REQUEST

Current Zoning: R-12MF(CD) (Multi-Family Residential, Conditional)
Proposed Zoning: N2-A(CD) (Neighborhood 2-A, Conditional)

SUMMARY OF PETITION

**STAFF
RECOMMENDATION**

• Proposed Request Details

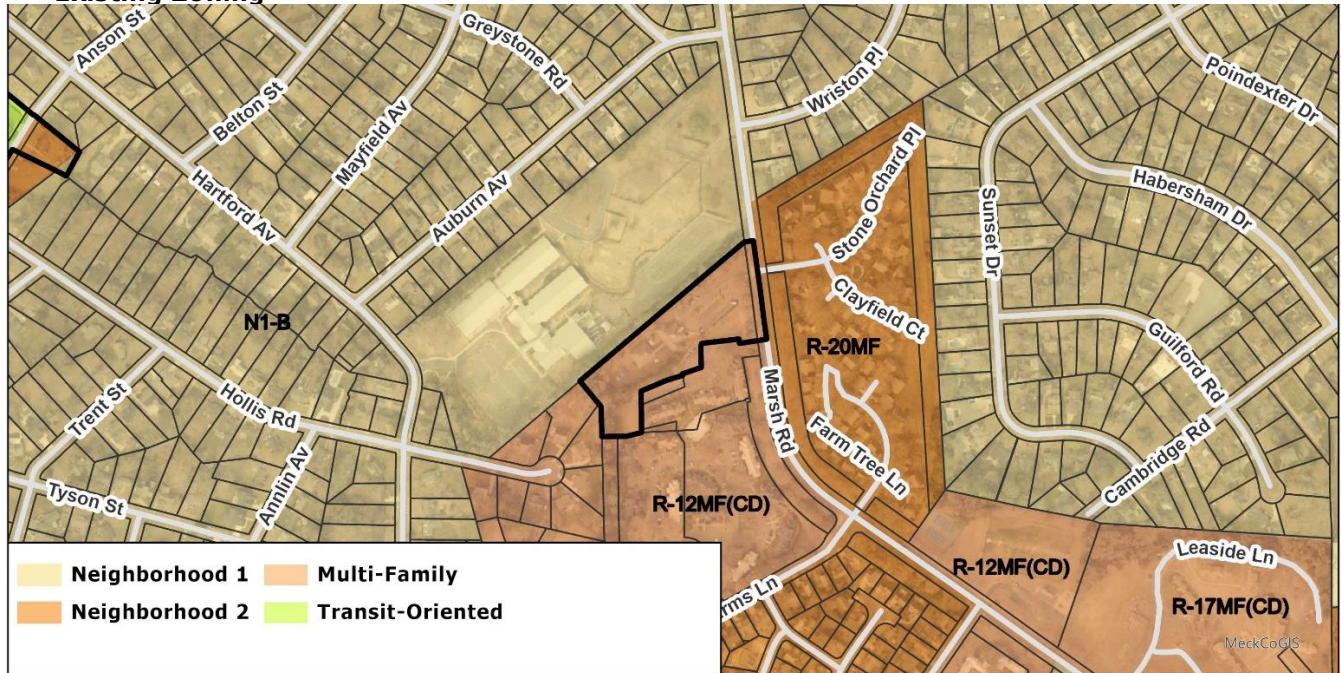
1. CDOT: Revise site plan and conditional note(s) to clarify a 40' vehicle turn around between gated entrance and back of sidewalk.

2. Fire: Must be a minimum width of 20 feet for undivided entry/exit or 16 feet for divided entry/exit.
3. Fire: All gates shall have a Knox Box or Knox Switch for fire department access.

5. Urban Forestry: Replanted tree save is not a default option and some preservation is required.
6. Urban Forestry: Refer to Charlotte Tree Manual for acceptable tree save dimensions.

8. Urban Forestry: Protected tree save must be a min of 30' wide.
9. Urban Forestry: There is a 10' no build zone around tree save area. This would apply to buildings and wall/enclosures.

10. Urban Forestry: Utilities are not permitted within tree save areas.
11. Entitlement Services: There is an approximately 60' berm along the front of the property. Adjust the site design to be consistent with existing development along Marsh Road which incorporates large setbacks.

12. Entitlement Services: Please specify what type of open space is being proposed.
13. Urban Design: Expand the footprint of open space and increase minimum open space dimension The allocation of 10' in front of the units for open space is narrow and will not be ample to program or activate with quality open space.

14. Entitlement Services: List the rezoning petition number.
15. Entitlement Services: Show adjacent building footprints on the plan
16. Entitlement Services: Prohibited materials should list limitations on the use in terms of percentage of the material on façades.
